# UNITED STATES PATENT AND TRADEMARK OFFICE

APPLICATION NO.	FILING DATE	FIRST NAMED INVENTOR	ATTORNEY DOCKET NO.	CONFIRMATION NO.
10/602,582	06/24/2003	John J. Breen	16356.803 (DC-04938)	1625
27683	7590	04/26/2006	EXAMINER	
HAYNES AND BOONE, LLP 901 MAIN STREET, SUITE 3100 DALLAS, TX 75202			TIBBITS, PIA FLORENCE	
			ART UNIT	PAPER NUMBER
			2838	
DATE MAILED: 04/26/2006

### DETAILED ACTION

This office action is in answer to the amendment filed 3/9/2006. Claims 1-24 are pending, of which claims 1-16 are withdrawn, while claims 17 and 24 are amended.

and in fig.1:

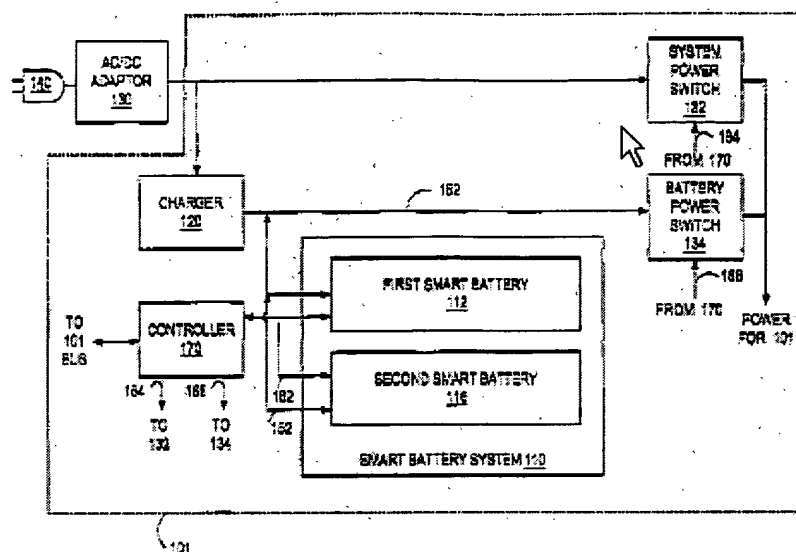
7. Applicant's arguments with respect to the claims have been considered but they are not persuasive: applicant amended claims 17 and 24 to include "the charge and discharge switches being opened in response to the electronics device and the controller being in agreement to charge one of the smart batteries, and either of the charge or the discharge switches being opened in response to directions from the electronics device or the controller", which is new issue.

The instant application describes in the specification at paragraph 0033:

"To advantageously reduce occurrences of operating conflicts during a charge operating condition switches 114 and 115 are closed when both, the smart electronics 113 and the controller 170, agree that the first smart battery 112 is in the charge operating condition. When both are in agreement the smart electronics 113 generates outputs, which result in closing switches 114 and 115, the outputs being transferred via control lines 182 and 183. In case of a disagreement, the logic i.e., the operating condition determined by the smart electronics 113 prevails. Operation of switches 118 and 119 is similar. For example, when the controller 170 instructs the first smart battery 112 to charge but the first smart battery 112 is already fully charged then the first smart battery 112 is able to override the request from the controller 170 to prevent an overcharge condition. Similarly, if the controller 170 instructs the first smart battery 112 to charge but the battery 112 detects an over current or over temperature condition then the battery 112 is operable to disconnect itself and terminate the charge request",

The '482 reference describes in fig.3:

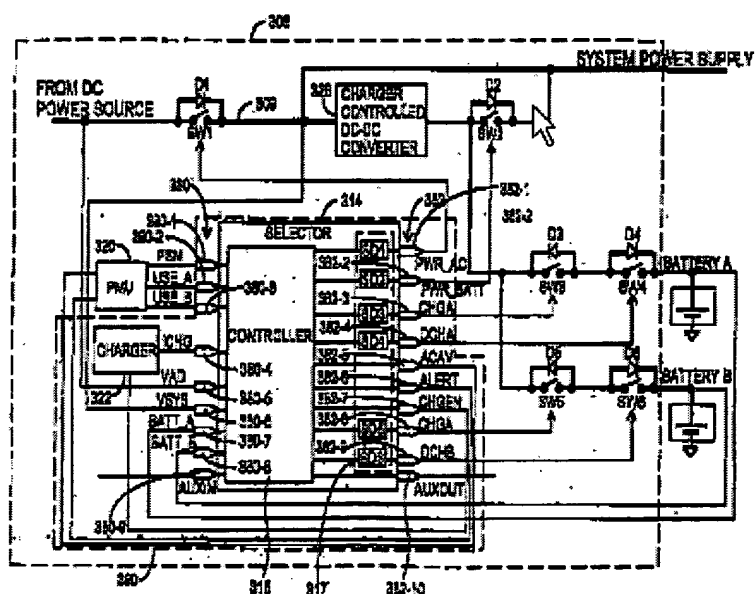
Therefore, the controller and the Smart Battery communicate with each other and operate according to feedback, so that the two circuits are equivalent. See ***MPEP §§ 2183- 2184***.
